WASTE MANAGEMENT OF HAWAII, INC.
92-460 Farrington Highway
Kapolei, Hawaii 96707
(808) 668-2985

**RE: Solid Waste Management Permit Application
For renewal with Modification for Expansion, No. LF-0065-07
Waimanalo Gulch Sanitary Landfill
Located at: 92-460 Farrington Highway, Kapolei, Hawaii 96707**

On behalf of the City & County of Honolulu (CCH), Waste Management of Hawaii, Inc. (WMH), the operator of the Waimanalo Gulch Sanitary Landfill (WGSL), is responding to the Department of Health's (DOH) December 2, 2009 letter concerning comments to our expansion and renewal permit application and engineering design. WMH appreciates receiving and welcomes the opportunity to address DOH's comments.

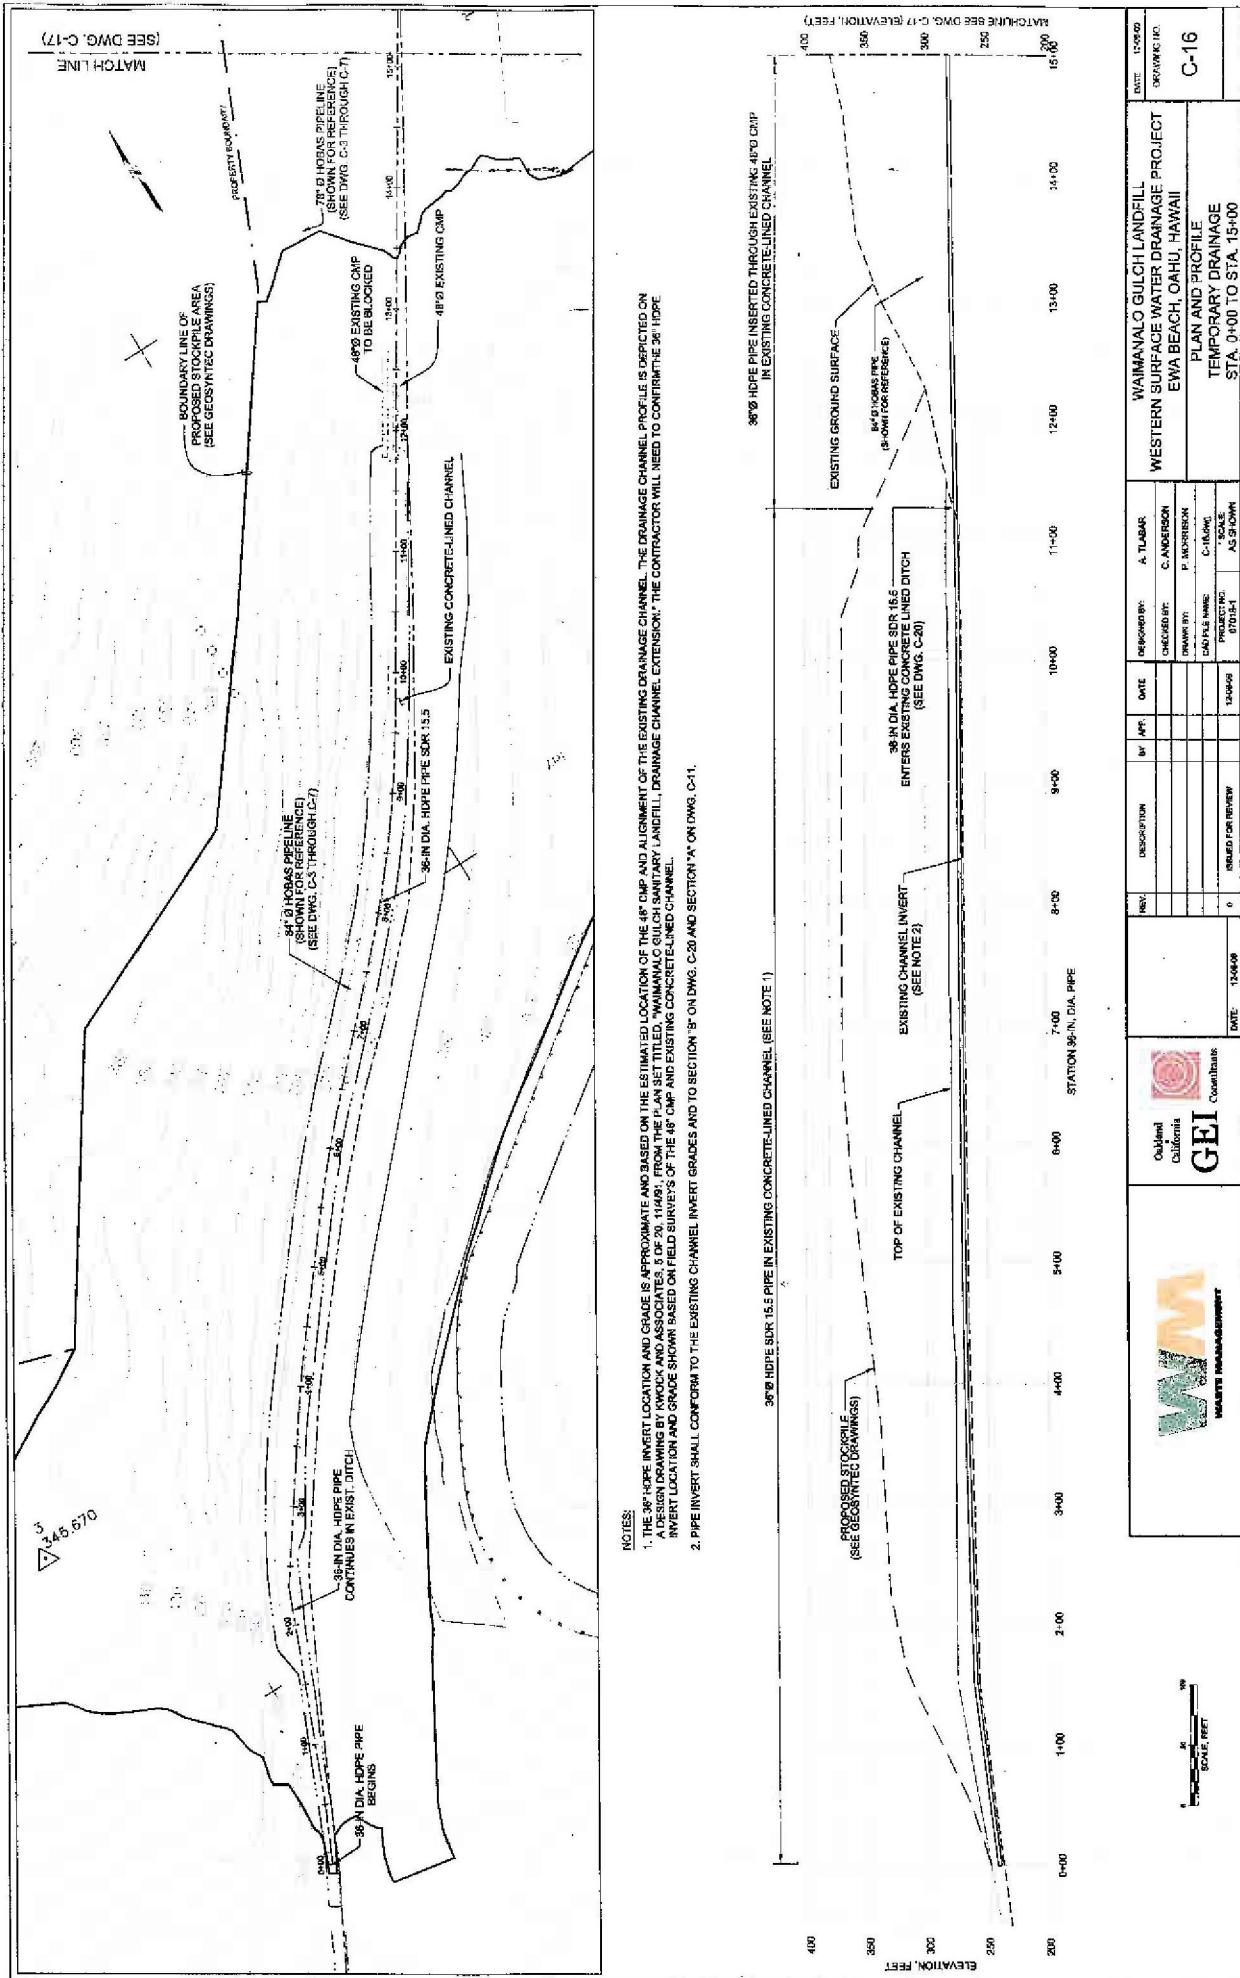
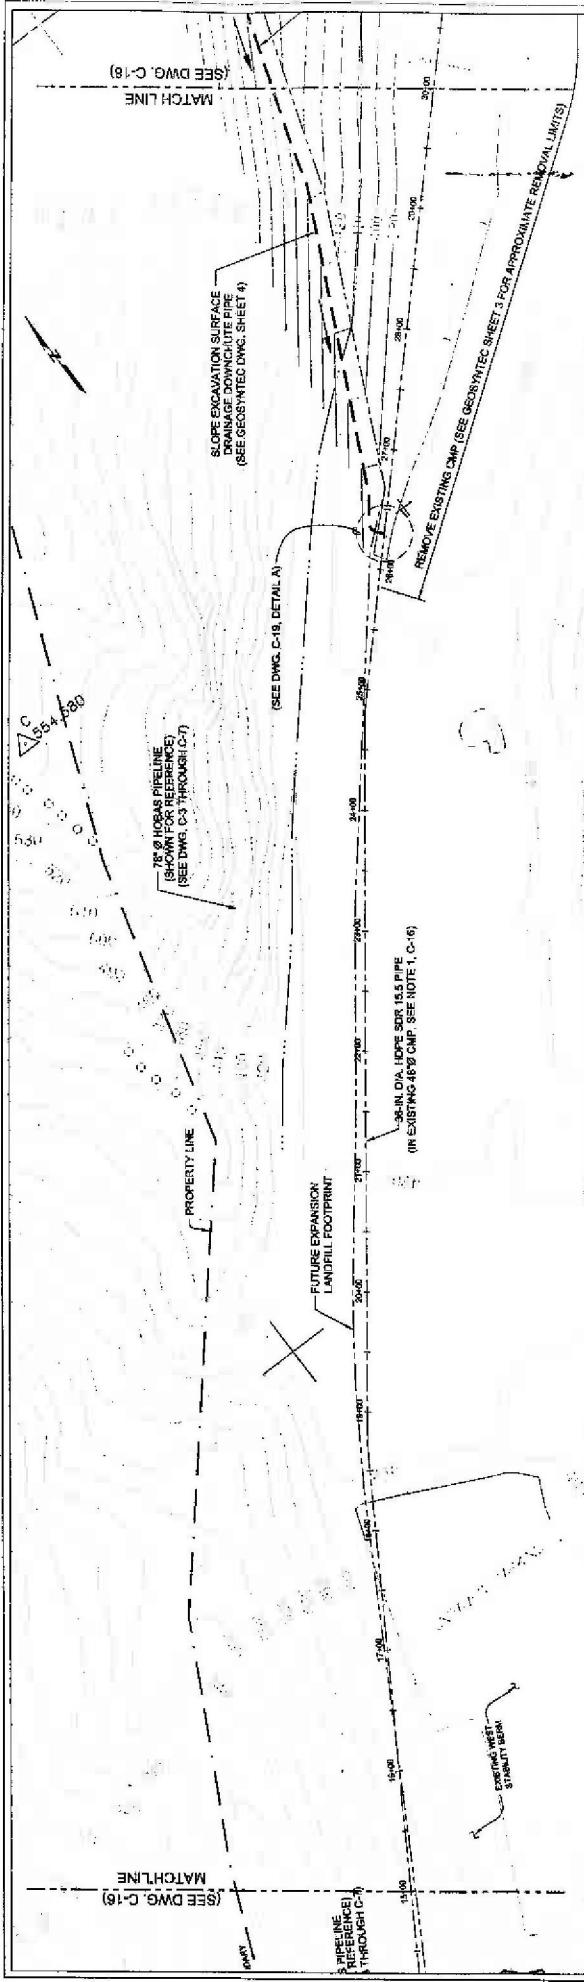
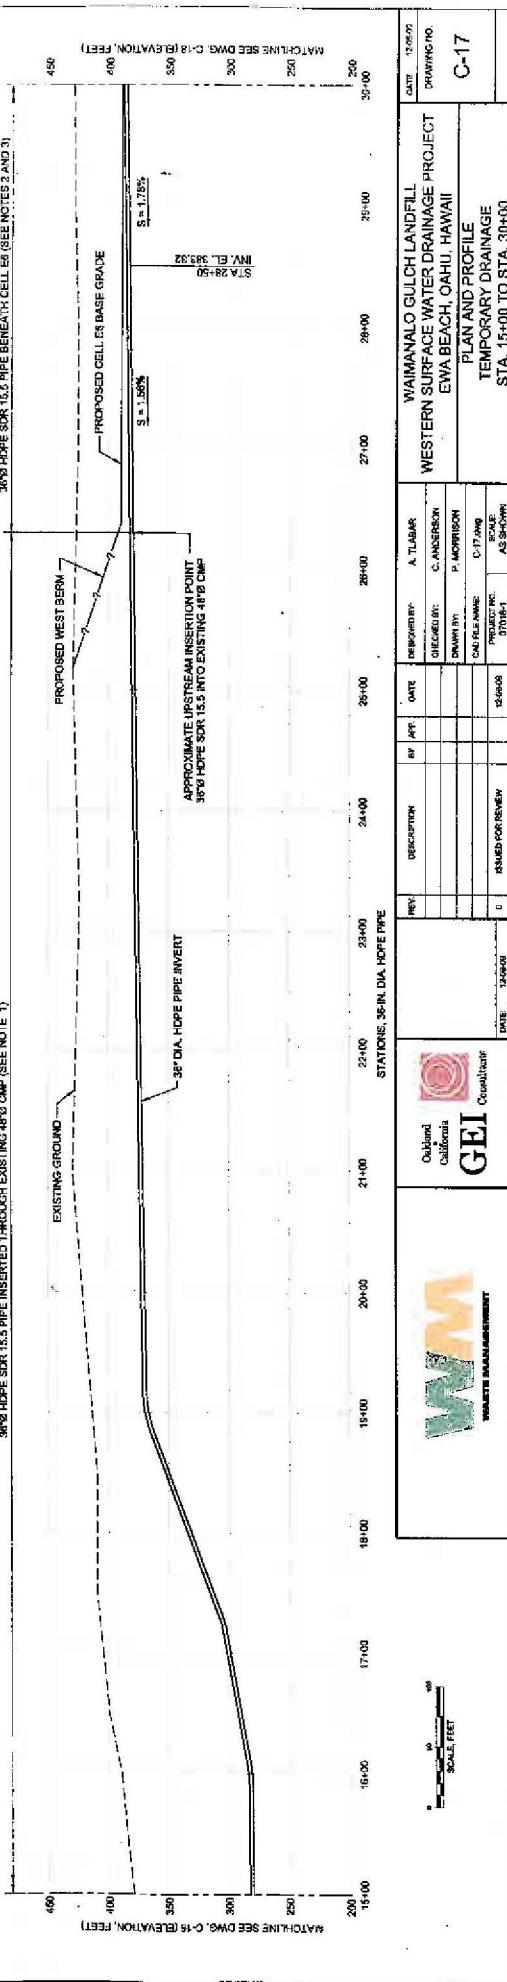
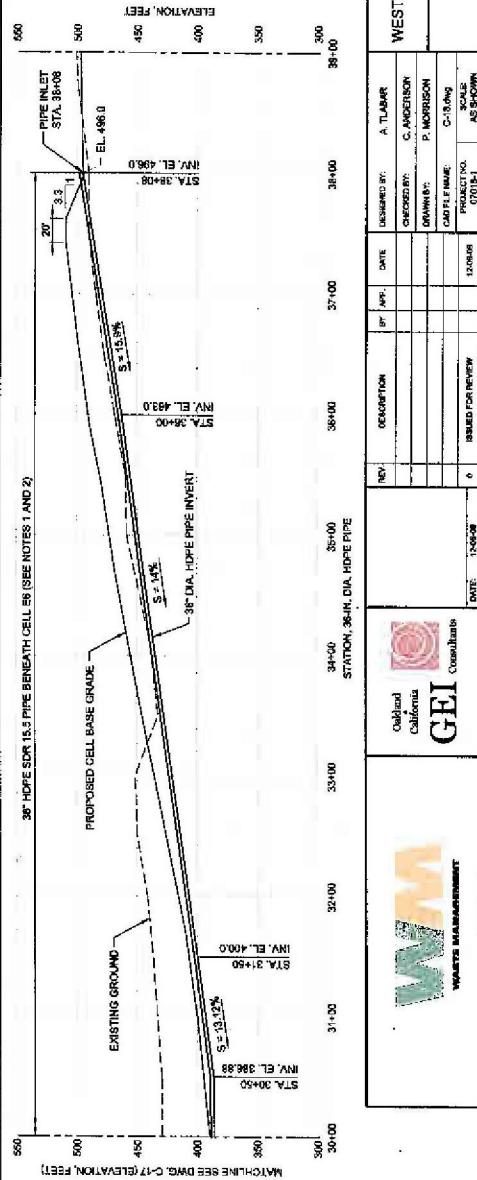
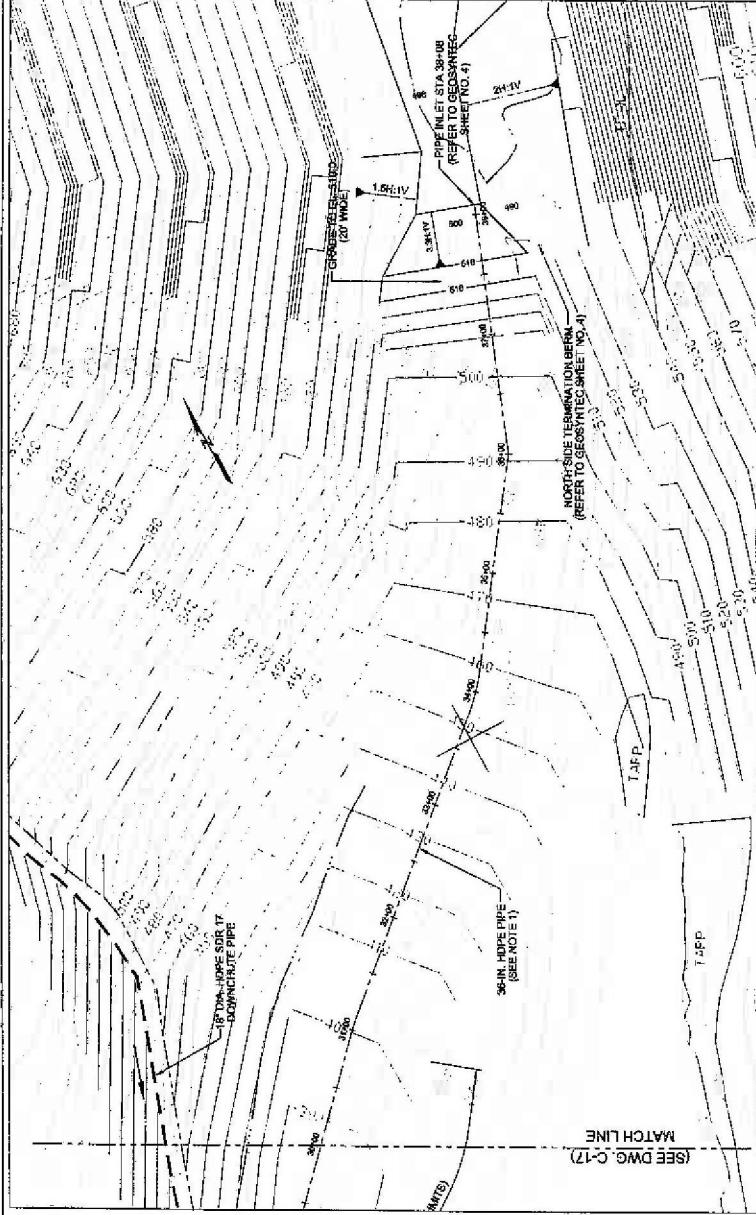
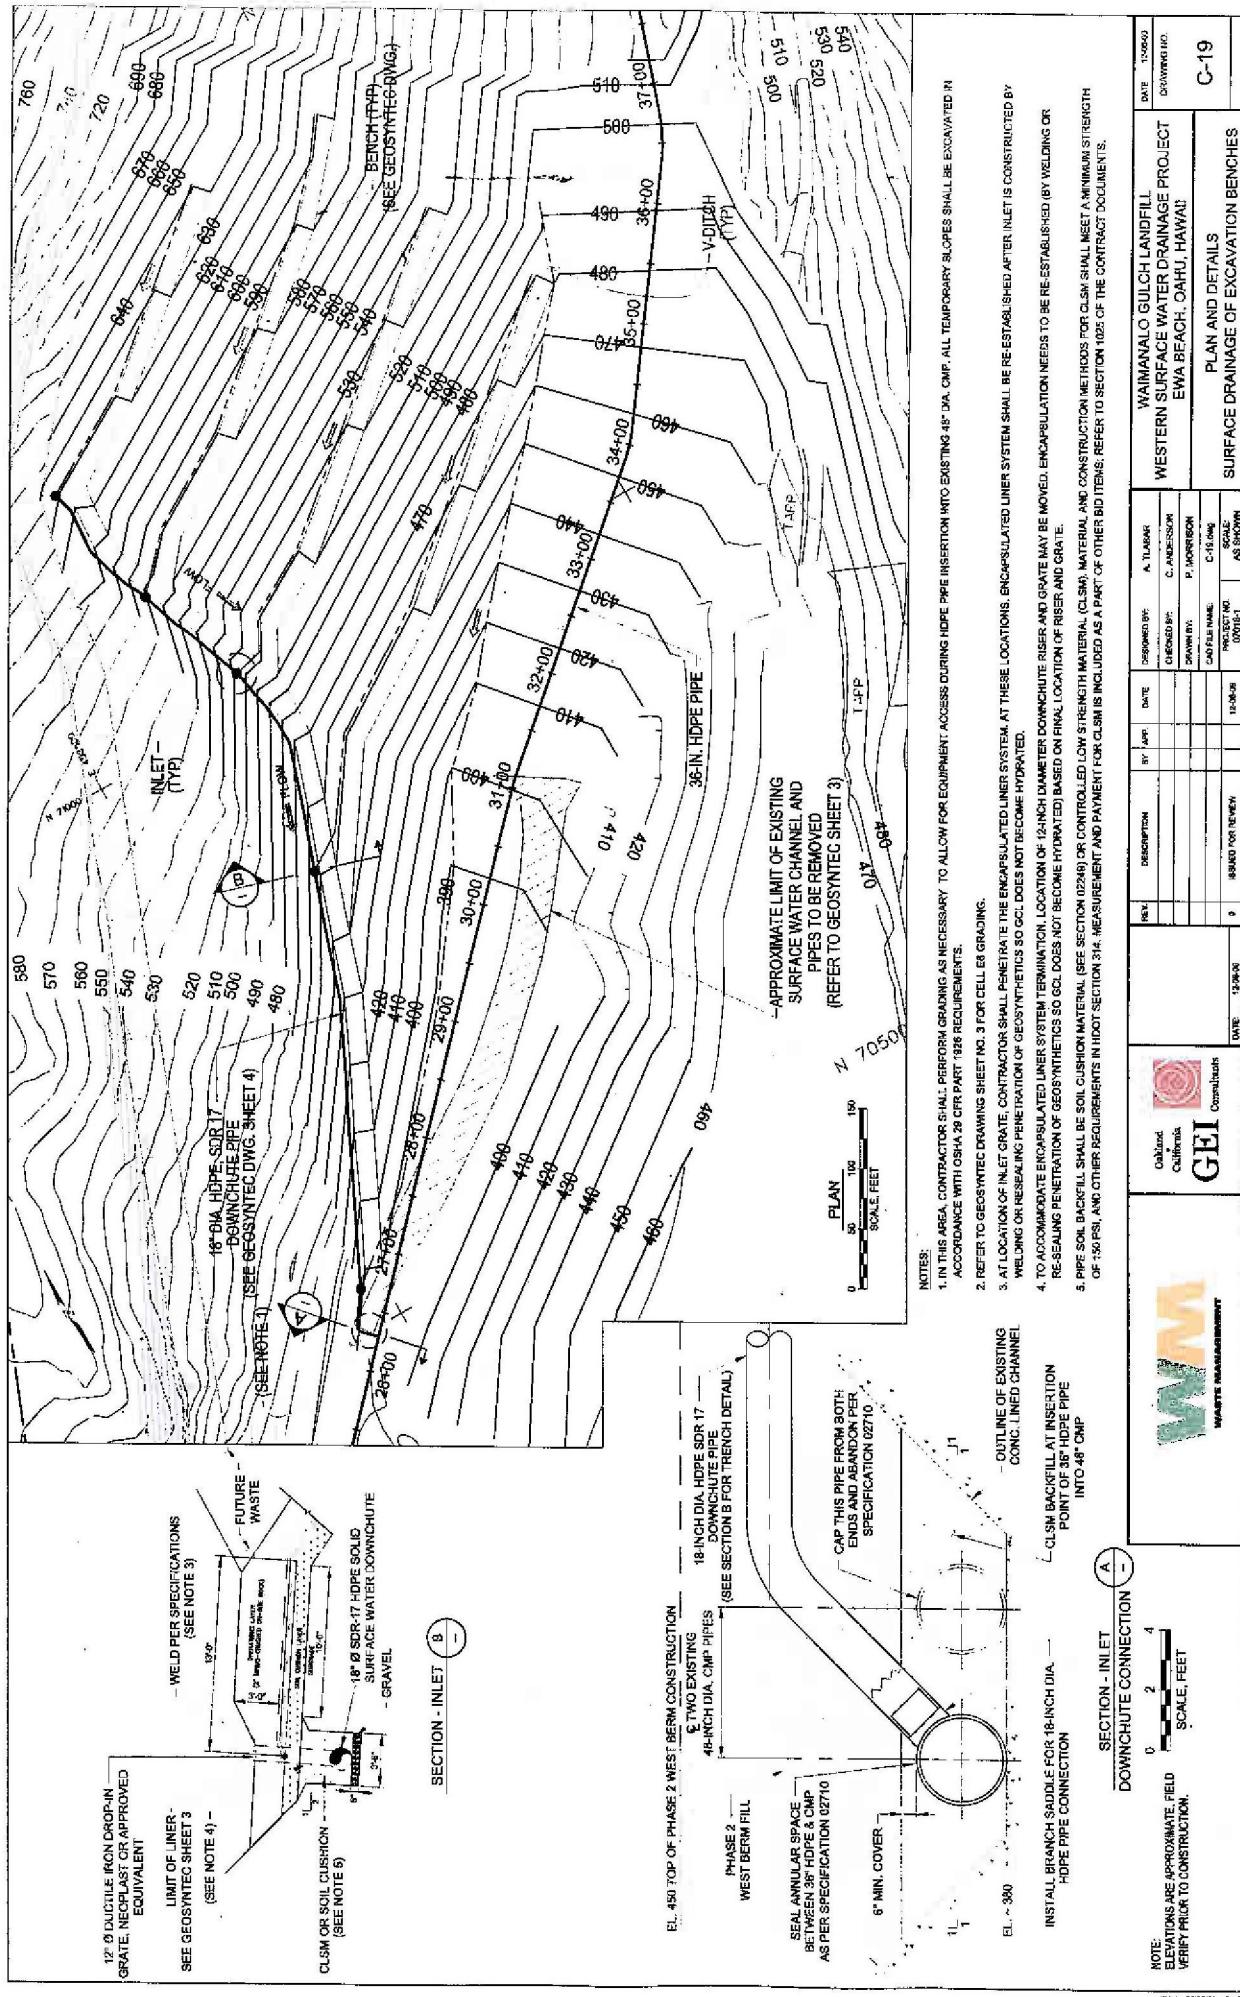
DOH Comment #3: *The subdrain trench containing the 30-inch and 36-inch diameter HDPE pipes, intending to drain surface water from the upper reaches of the gulch, do not have invert elevations and details on how the HDPE pipes are to be supported.*

DOH Comment #4: *Details of the connection of the new subdrain HDPE pipes to the existing 48-inch diameter corrugated metal pipes (CMPS) in the existing concrete channel are not provided. Portions (about 480 lineal feet) of the existing concrete channel and CMPS are to be removed, and the new subdrain HDPE pipes will connect to the existing CMPS downslope of the bottom of cell E6. Without invert elevations for the new subdrain trench and the existing CMPS, it is not known what elevation adjustments will be needed for the new HDPE pipes, which are running seven (7) feet below the cushion layer underlying the base liner, to meet the existing CMPS. It would appear that the HDPE pipes would need to rise up to meet the CMPS.*

WM Response #3: The pipe in a trench design cited by the HDOH was modified. Stormwater from the upper reaches of the landfill footprint and, temporarily, flow from the drainage located east of the old Nike site will now be conveyed in a single 36-inch diameter HDPE temporary diversion pipe that will discharge into the existing concrete channel downstream of the temporary stockpile (approximately 1,600 feet upstream of Farrington Highway). The 36-inch diameter HDPE temporary diversion pipe will be inserted into the east existing CMP, and the west CMP will be abandoned by capping at the upstream and downstream ends once the west side drainage channel has been completed. After the downstream end of the 36-inch HDPE pipe exits the east CMP, it will be placed next to the Western Surface Water Drainage Pipe in the existing channel and backfilled with controlled low strength material (CLSM). The downstream portion of the existing concrete channel will be preserved to convey discharge for the temporary diversion pipe and the interior landfill drainage to the existing sedimentation and stilling basin.

This modification is described in Appendix G, Western Bypass Channel of the *Revised Engineering Report for Landfill Expansion* submitted to the HDOH on 24 November 2009. We have attached drawings (C-16 through C-20) showing plan and profile details of the 36-inch HDPE temporary diversion pipe to supplement the description of the system provided in Appendix G.

WM Response #4: The temporary surface run-on drainage control will now consist of a single 36-inch HDPE temporary pipe as discussed in the Response to Comment No. 3 above and depicted in attached Drawings C-16 through C-20. The temporary diversion pipe will be inserted into the existing, eastern 48-inch CMP located below the West Berm area. As shown on attached Drawings C-17 and C-18, the HDPE pipe will extend through the remaining length of the 48-inch CMP and then exit the CMP in the existing channel beneath the proposed stockpile area. These drawings also show invert elevations for the 36-inch HDPE diversion pipe in the Cell E6 area and West Berm areas. The HDPE diversion pipe invert elevations in the West Berm area are based on the approximate location and grade of the 48-inch CMP pipe and alignment of the existing channel (i.e., the invert of the 48-inch CMP was placed in the existing channel). Based on the alignment shown on Drawing C-17, we do not anticipate the HDPE pipes will need to rise up to meet the CMP invert elevation.
